PLANS AND DOCUMENTS referred to in the
DEVELOPMENT APPROVAL

Application No: OPW/2020/1583

LOT 1, 84-160 CHRISTENSEN
ROAD SOUTH, STAPYLTON

SEDIMENT AND EROSION
CONTROL PLAN

1 BOULDER RETAINING WALL DETAIL NTS

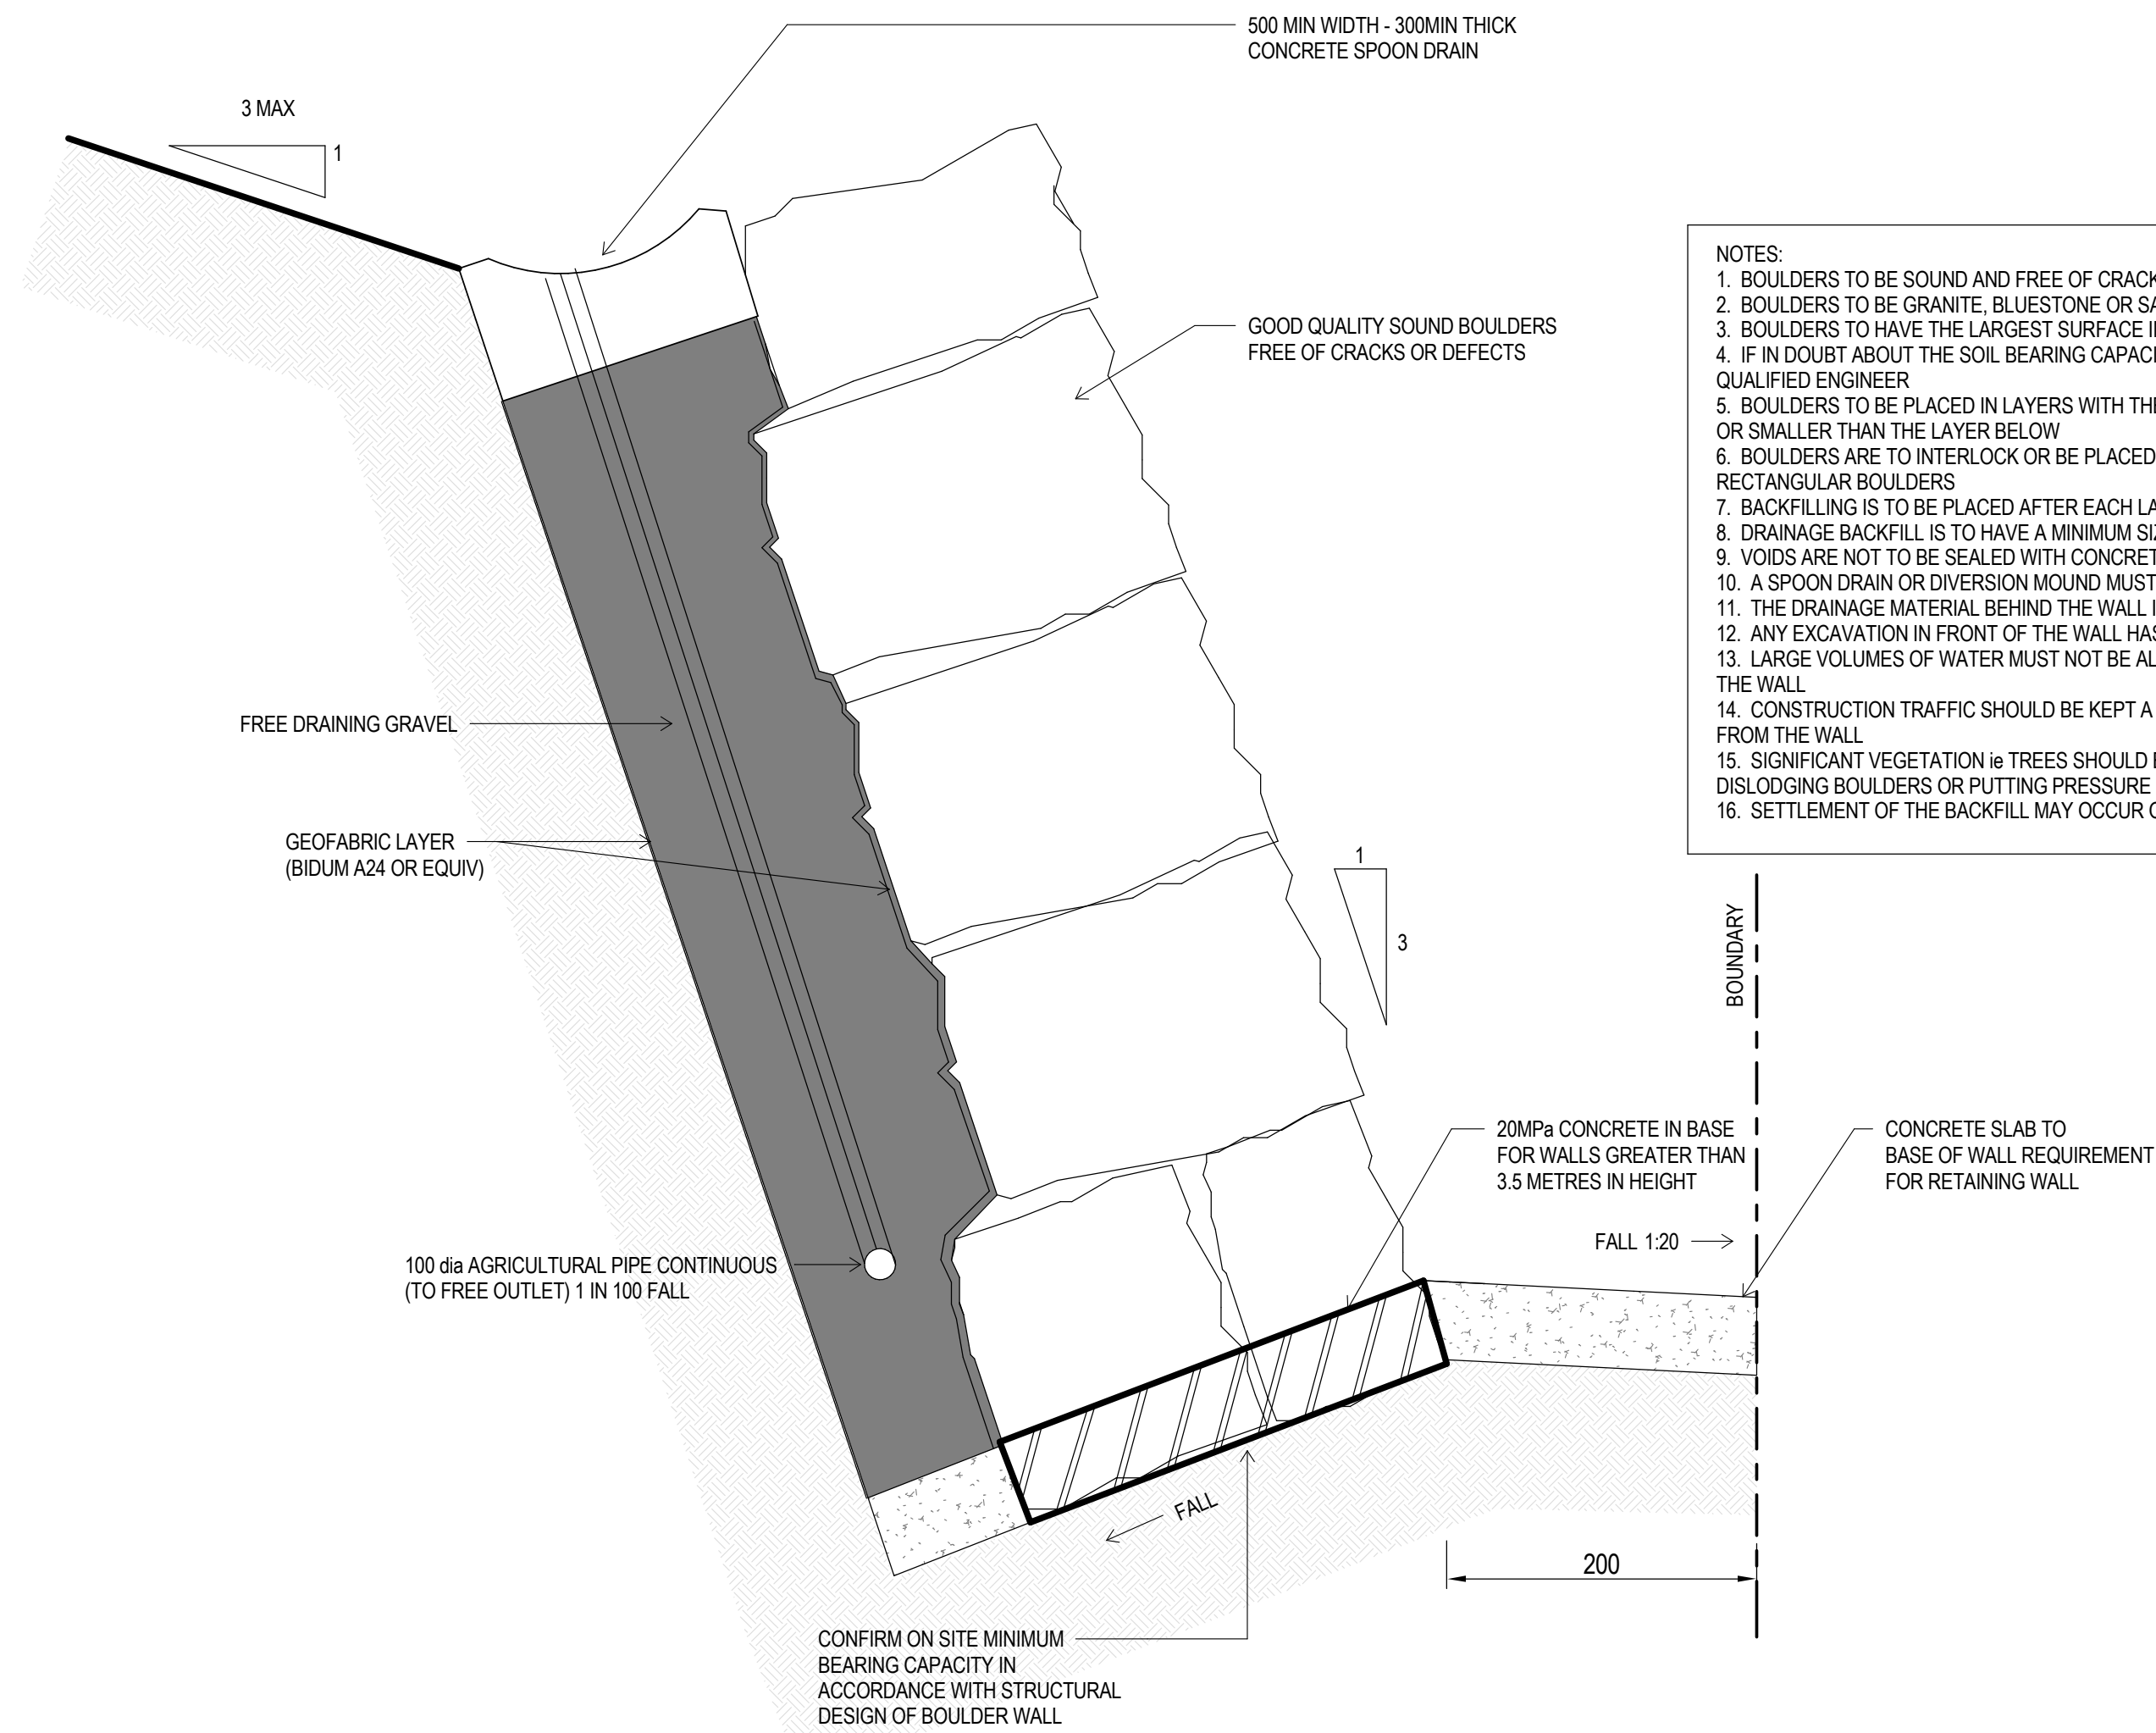
NOTE THAT RETAINING WALLS ARE
CONSIDERED BUILDING WORKS AND
REQUIRE A BA APPROVAL.
NOTWITHSTANDING THIS, THE ENTIRE
RETAINING WALL INCLUDING THE
FOOTING MUST HAVE A MINIMUM
SETBACK OF 200MM FROM PROPERTY
BOUNDARY.

Title
EXISTING SERVICES PLAN

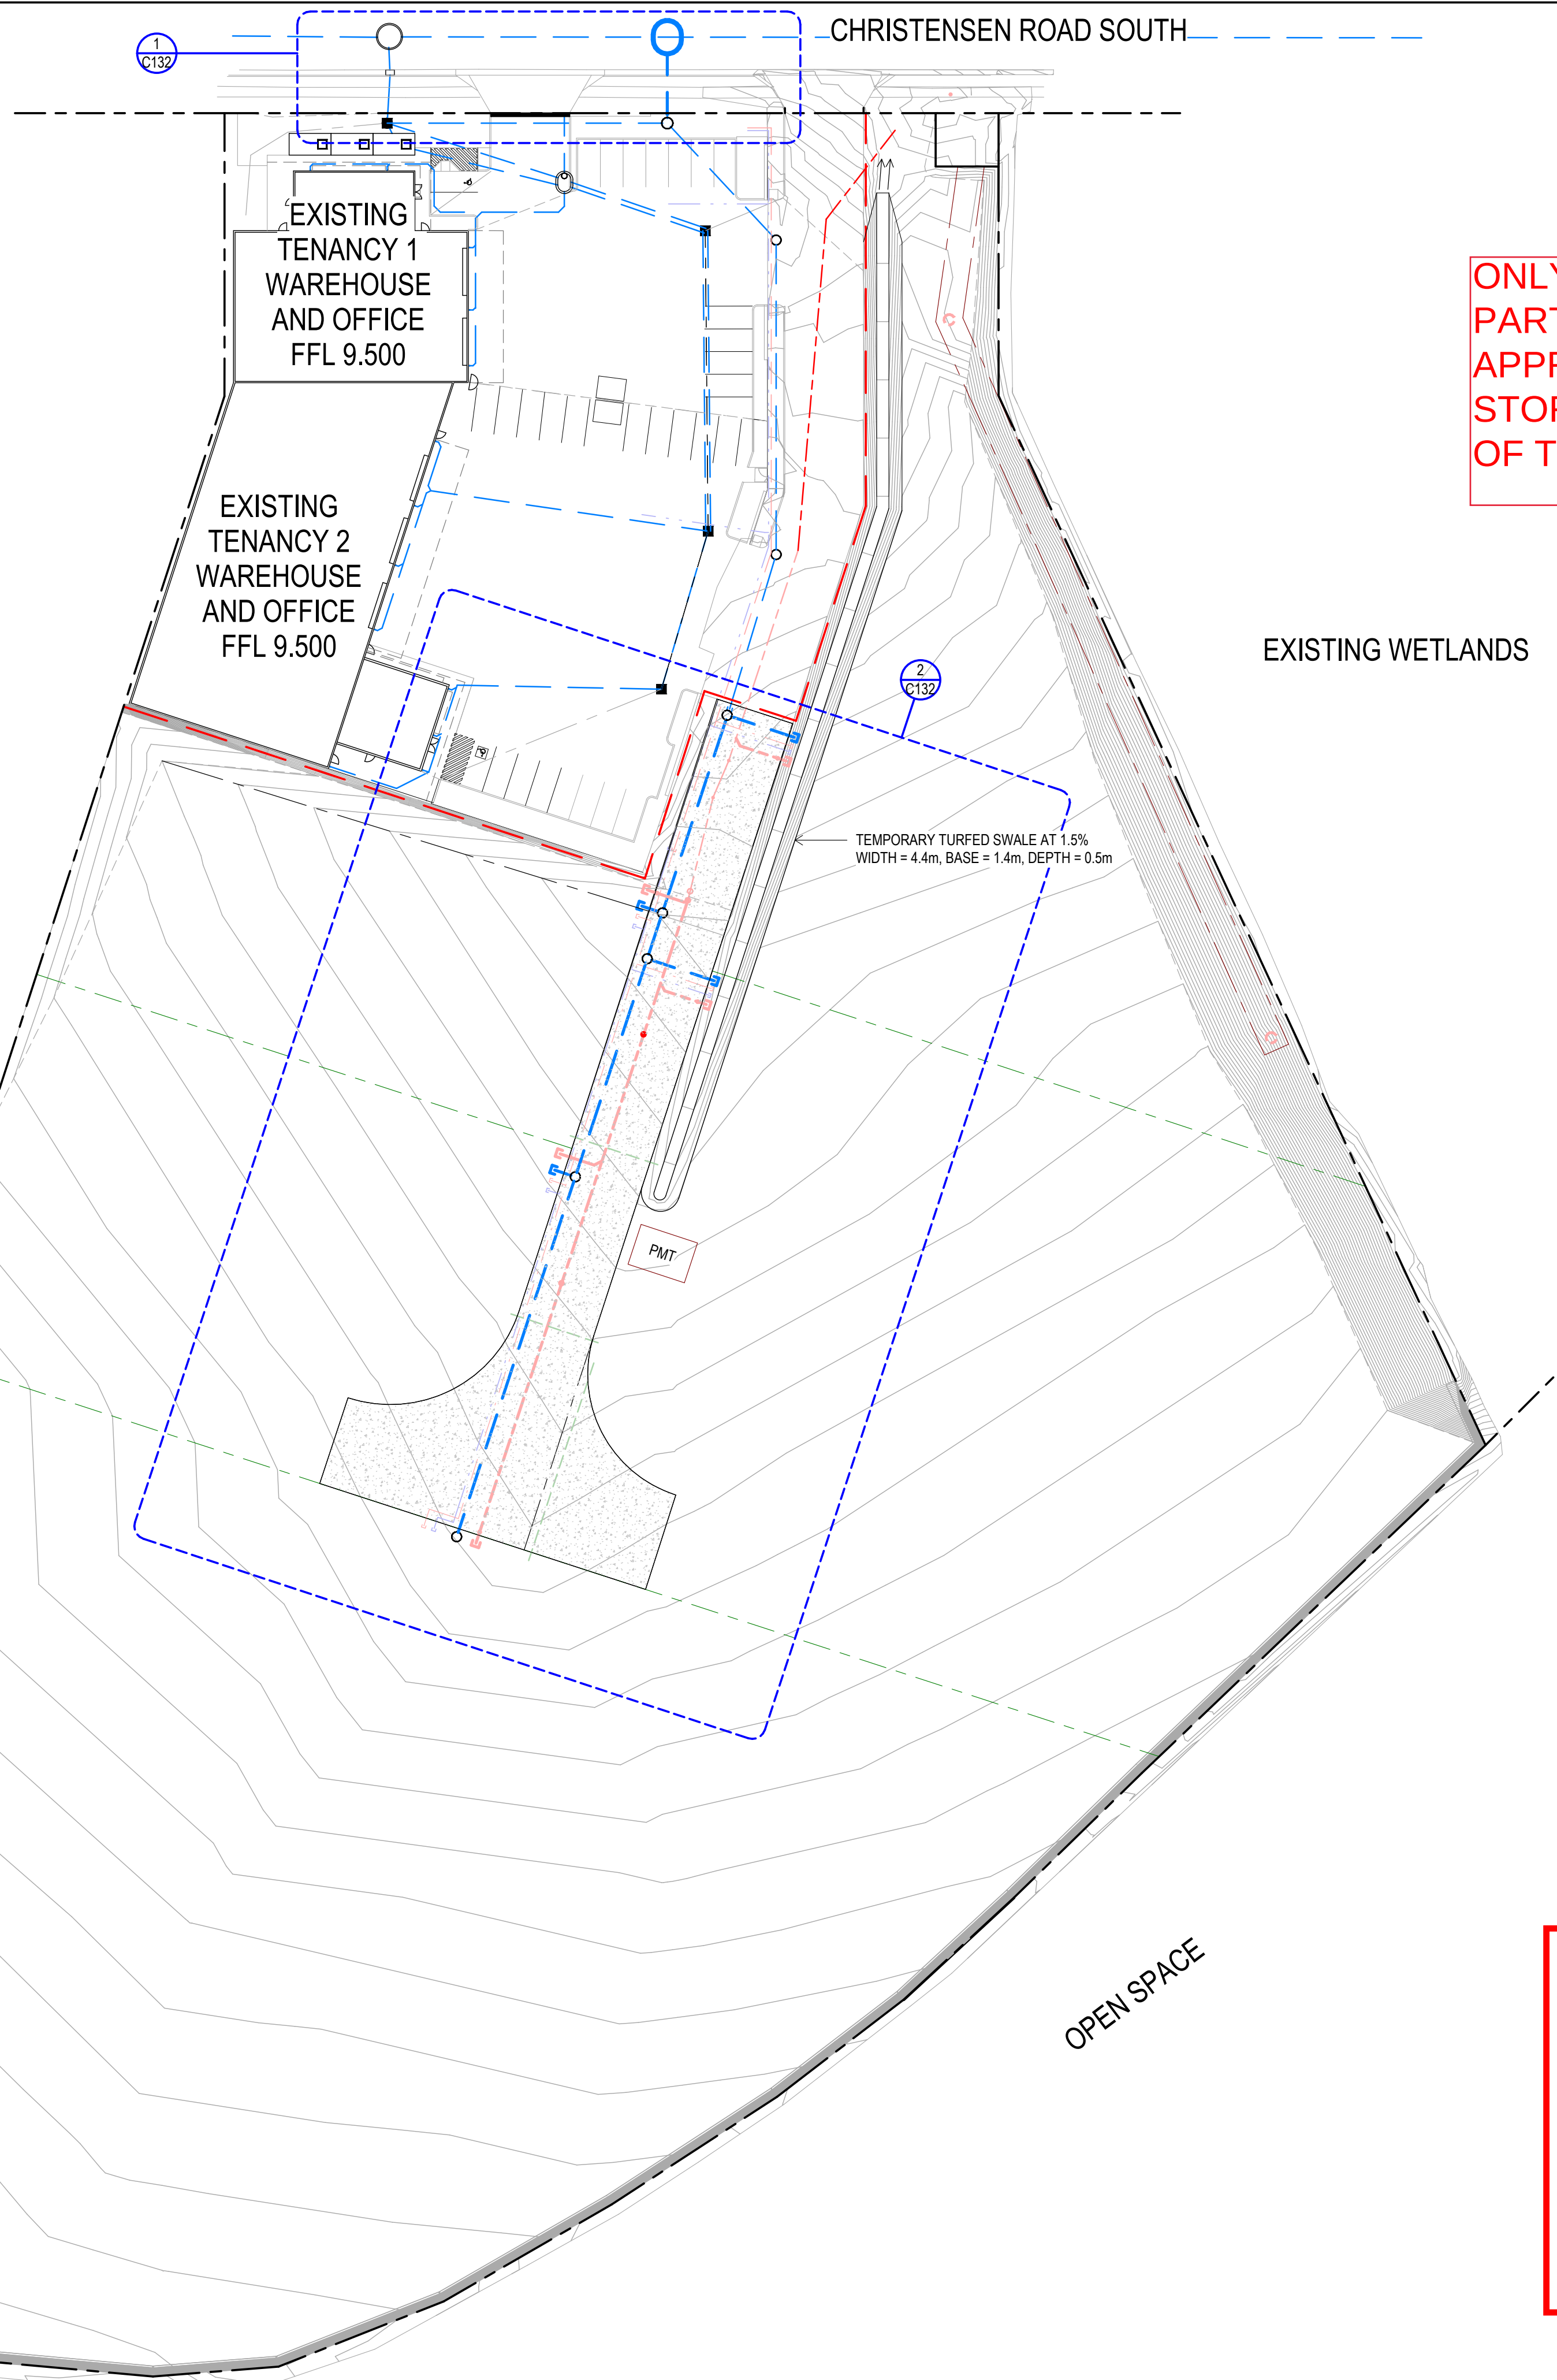
THIS OPERATIONAL WORKS APPROVAL
COVERS THE CHANGE TO GROUND LEVEL
AND STORMWATER CONNECTION WORKS
ONLY, ALL OTHER WORKS SHOWN IN THE
PLAN ARE NOT PART OF THIS
ASSESSMENT AND APPROVAL.

Title
STORMWATER PLAN

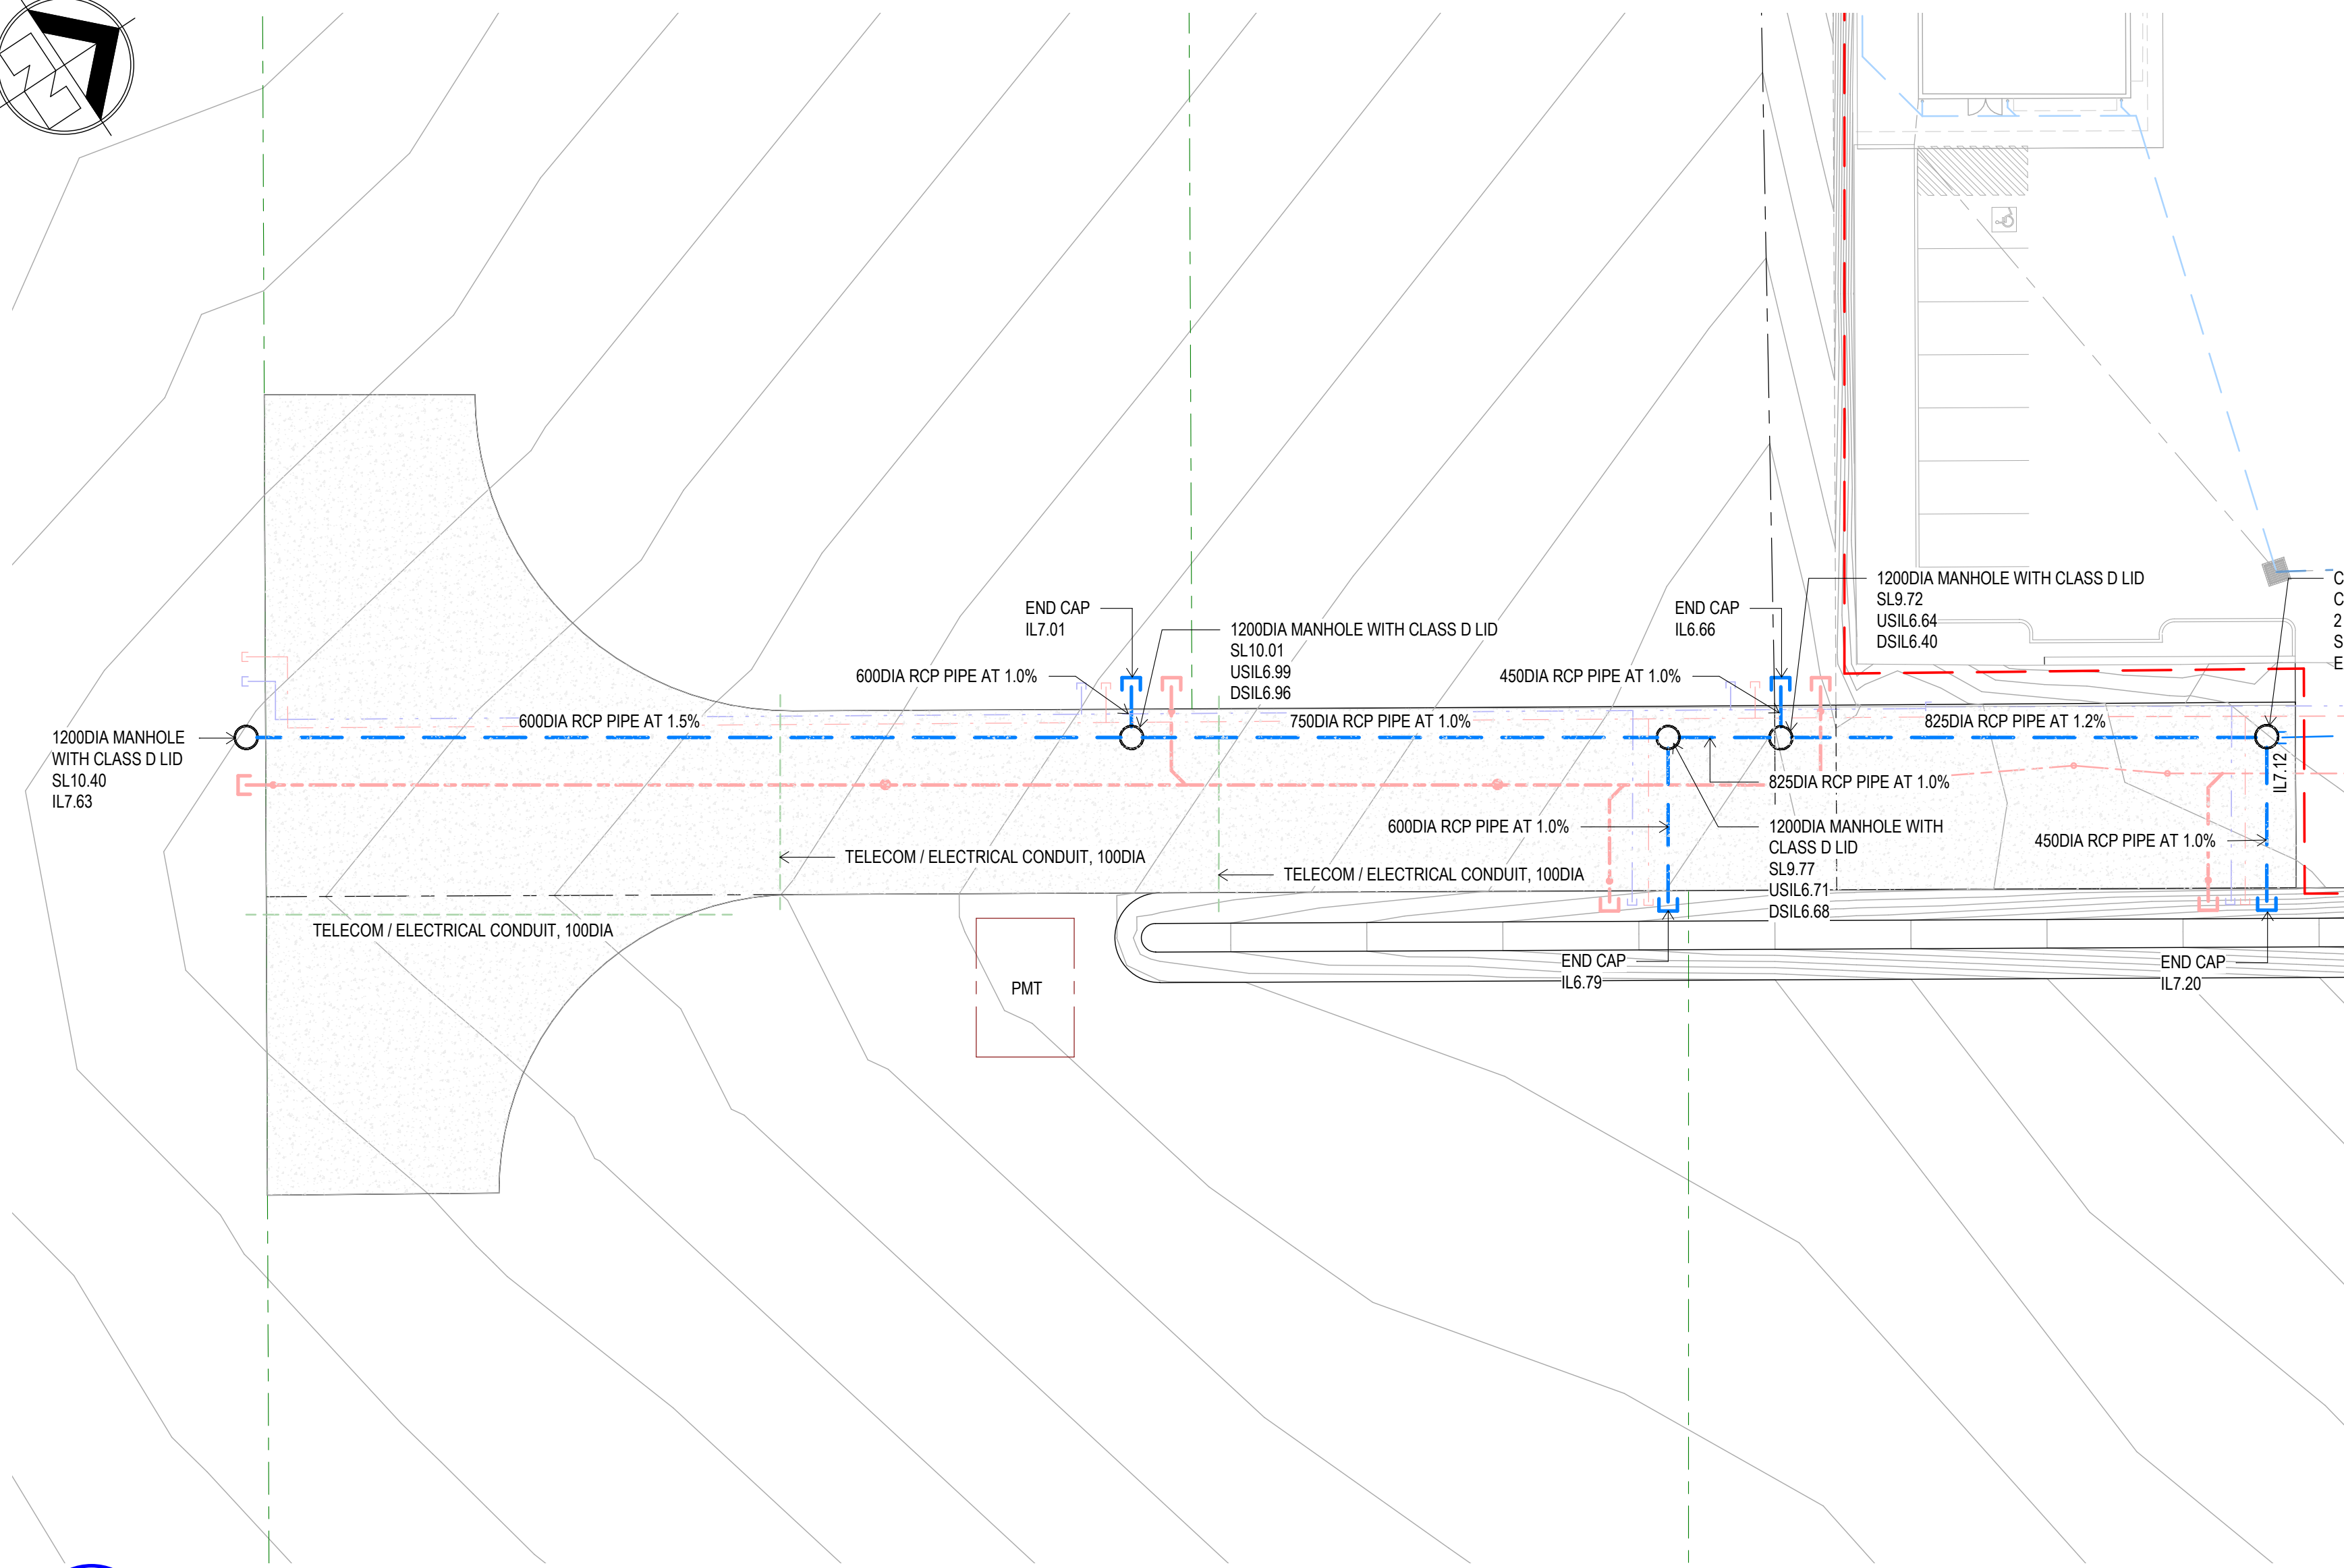
ONLY STORMWATER CONNECTIONS ARE
PART OF THIS OPERATIONAL WORKS
APPROVAL, INTERNAL PRIVATE
STORMWATER DRAINAGES ARE NOT PART
OF THIS OPERATIONAL WORKS APPROVAL.
